Access Compliance Report

Public Rights-of-Way

(Curb Ramps)

Intersection ID: 13572	Main Street: WINGATE_AV	Cross Street: MAYFAIR_AV	Location: SE
ADA ID: 7AE79EF186B1	Ramp Type: BlendTrans2	Initial Pass/Fail: Fail	Overall Compliance: No
		Severity Score: 12.5

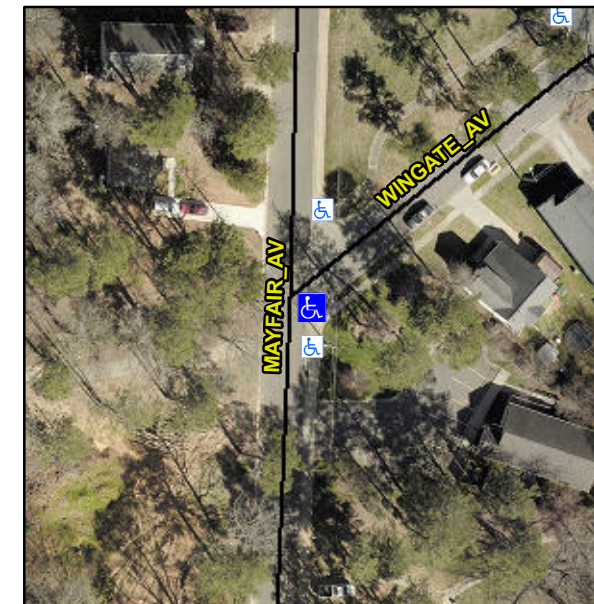
Not Found, R304.5.3

Compliance	Description	Data	Compliance	Description	Data
N/A	Ramp Length (in)	91.0	Yes	BlendTrans Slope (%)	3.6
Yes	Ramp Width (in)	48.0	No	BlendTrans XSlope (%)	5.3
N/A	Flare Type LT	N/A	N/A	Flare Type RT	N/A
N/A	Flare Slope LT (%)	N/A	N/A	Flare Slope RT (%)	N/A
N/A	Flare Traversable LT?	N/A	N/A	Flare Traversable RT?	N/A
N/A	Landing Length (in)	N/A	N/A	DWS Provided?	N/A
N/A	Landing Width (in)	N/A	N/A	DWS Contrast?	N/A
N/A	Landing Slope (%)	N/A	N/A	DWS Length (in)	N/A
N/A	Landing X Slope (%)	N/A	N/A	DWS Full Width?	N/A
N/A	Landing Curb? (Y/N)	N/A	N/A	DWS Offset (in)	N/A
N/A	Shared Landing?	N/A			
N/A	Gutter Ponding?	N/A	N/A	Gutter Slope (%)	N/A
N/A	Gutter Lip Ht (in)	N/A	N/A	Gutter X Slope (%)	N/A
N/A	Painted X Walk1?	No	N/A	Painted X Walk2?	N/A
	X Walk 1 Direction	To N		X Walk 2 Direction	N/A
	X Walk 1 Width (in)	N/A		X Walk 2 Width (in)	N/A
	X Walk 1 Slope (%)	7.7		X Walk 2 Slope (%)	N/A
	X Walk 1 X Slope (%)	1.2		X Walk 2 X Slope (%)	N/A

N/A	Ramp inside XWalk1?	N/A	N/A	Ramp inside XWalk2?	N/A
	Road Slope (%)	1.2		Clear Space?	N/A
	Road X Slope (%)	7.7	N/A	Clear Space to XWalk (in)	N/A
N/A	Any Obstructions?	N/A	N/A	Storm Grate/Utility Hazard?	N/A
	Obstruction Type			Storm Grate/Utility Type	
		N/A			N/A
			Yes	Surface Condition? (G/P)	Good
			No	Curb Slope (%)	22.6

Remove & Replace Curb Ramp With Two New Directional Ramps or Equivalent.
